Technical Policy Guidance for DAB Multiplex Licensees

Published as Annex 2 to Ofcom's Statement on Revisions to Digital Radio Technical Codes.

This is a marked-up version showing:

- a) the proposed changes to the 2014 revision of this document which were published as part of the February 2019 consultation, and
- b) the subsequent revisions to these proposed changes at the conclusion of the consultation process.

Figure 1—Existing site procedure

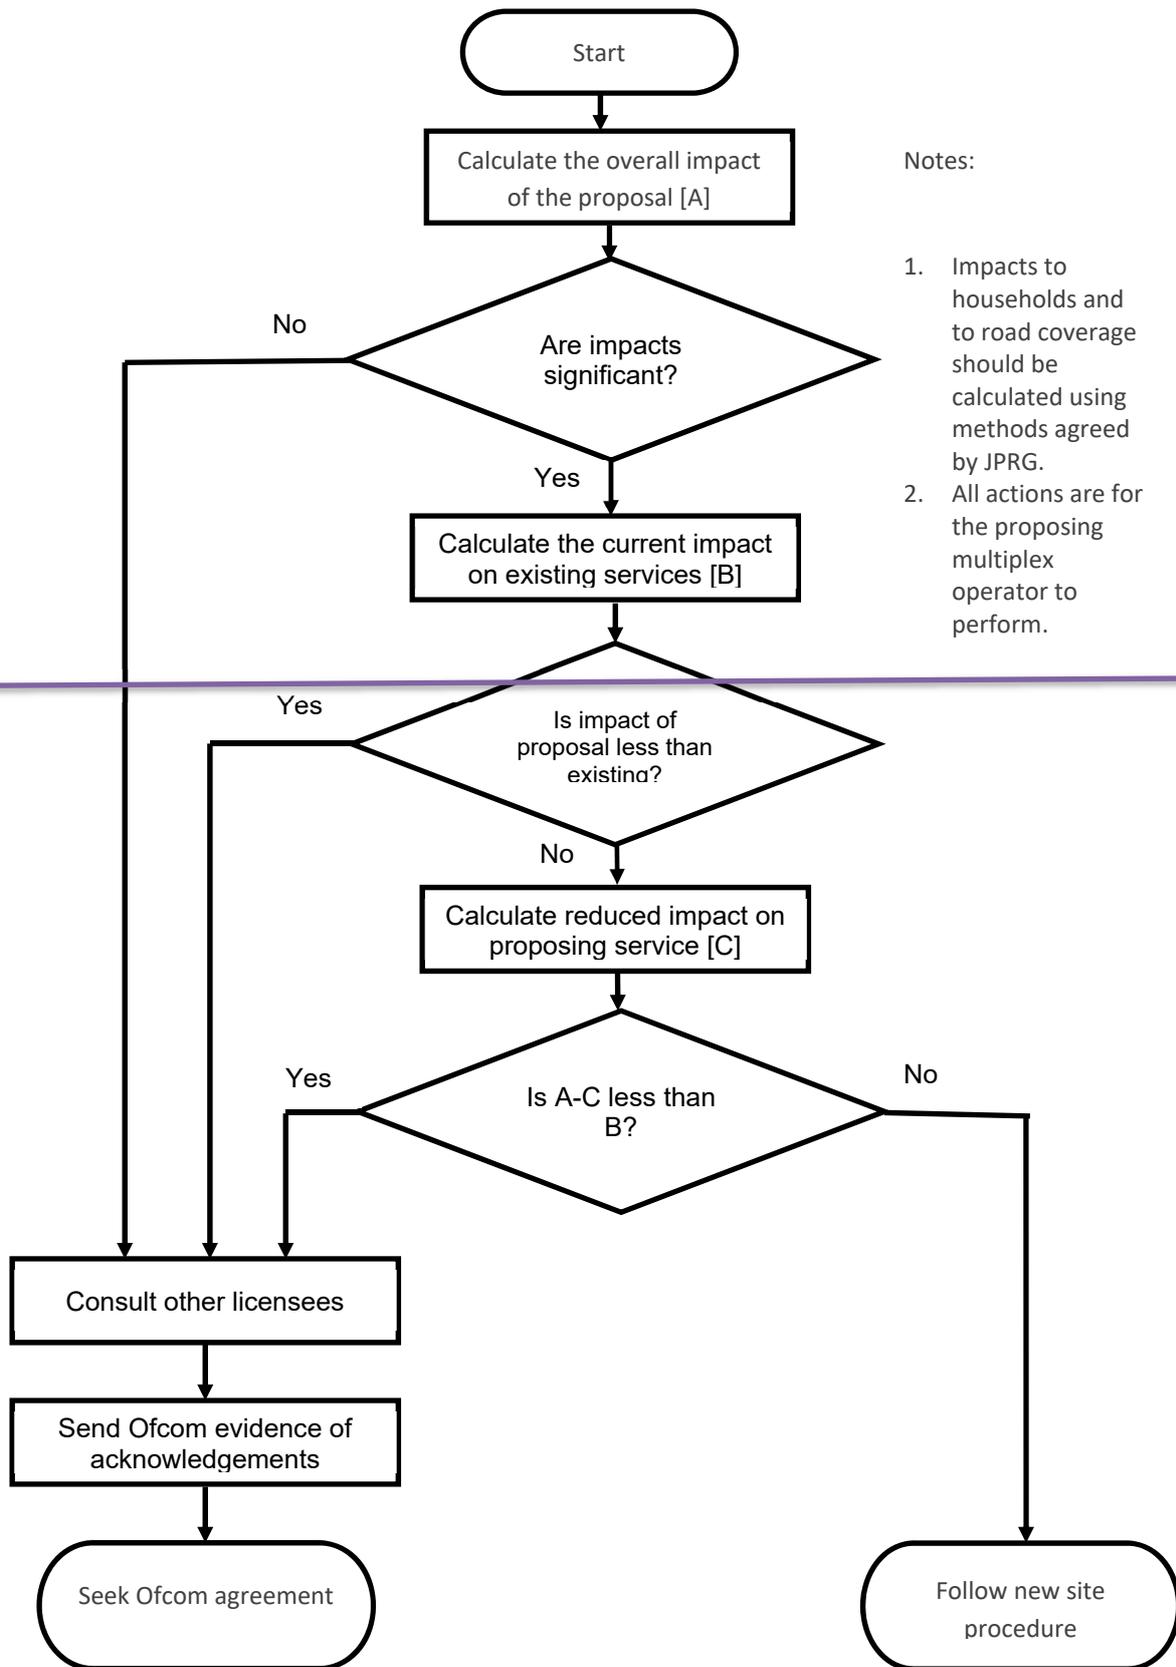
3.14 — Figure 1 below illustrates the process for giving consideration to a proposal to add a multiplex to an existing DAB transmission site. The process is also described below. In all cases the impact on both household and road coverage will be calculated.

Figure 2—New site procedure

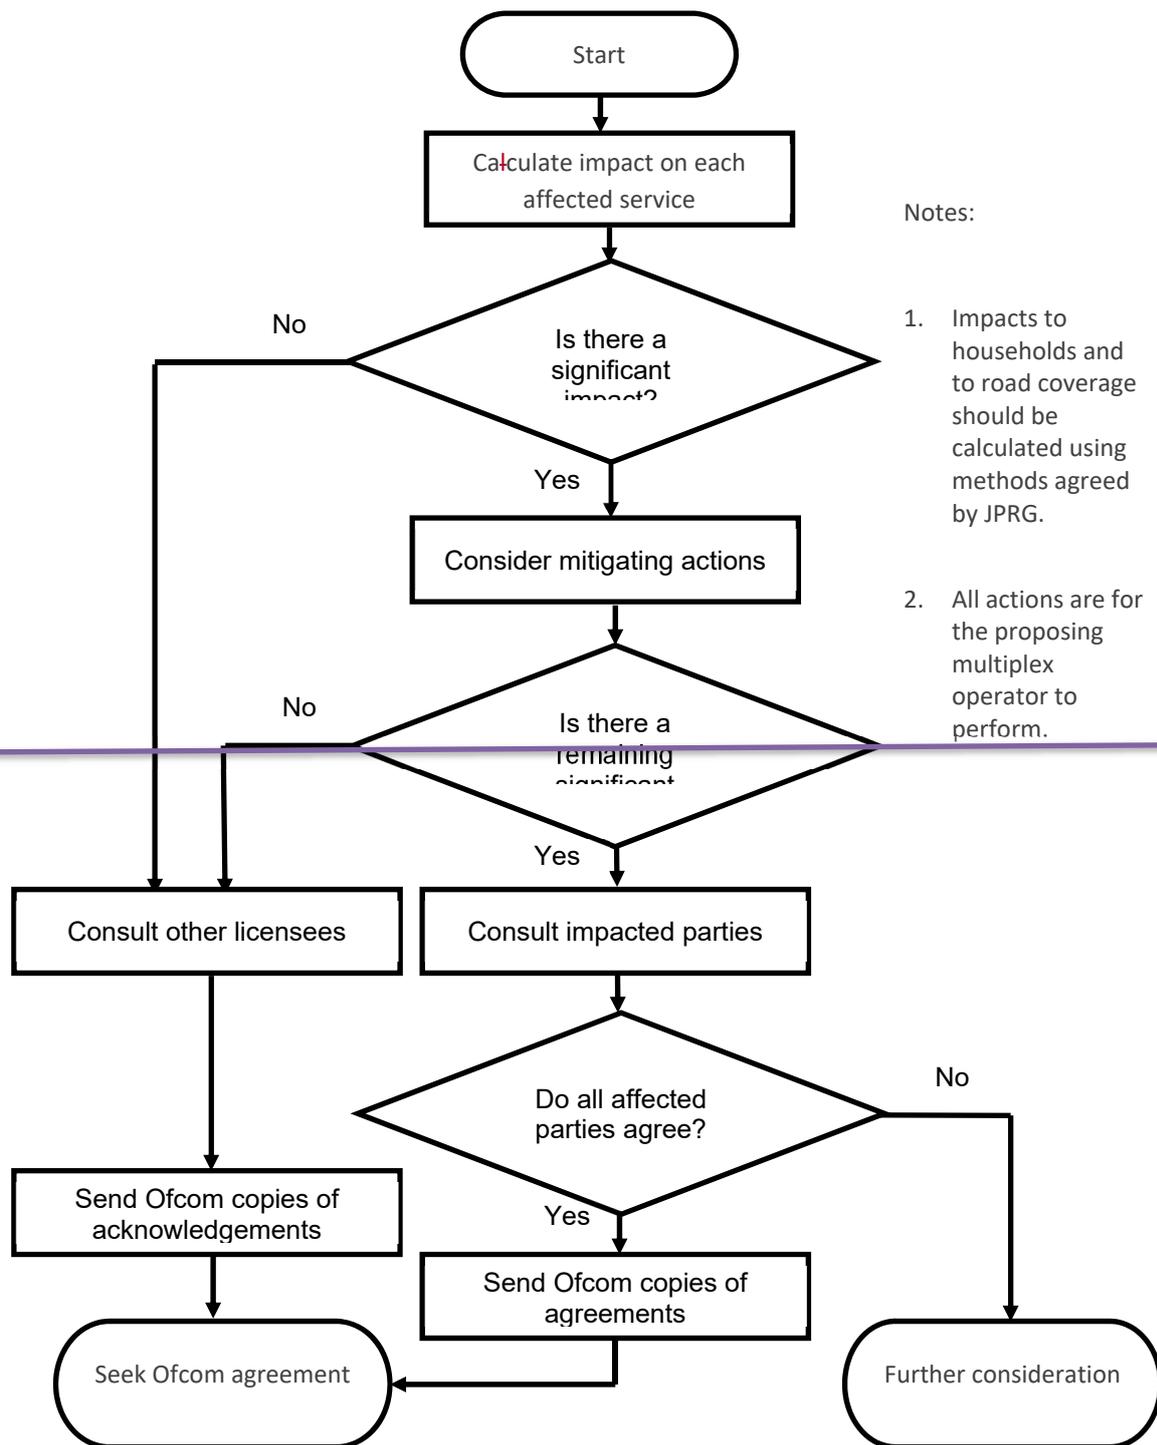
3.26 — Figure 2 illustrates the process for giving consideration to a proposal to add a multiplex to a transmission site not used for DAB. The process is also described below. In all cases the impact on both household and road coverage will be calculated.
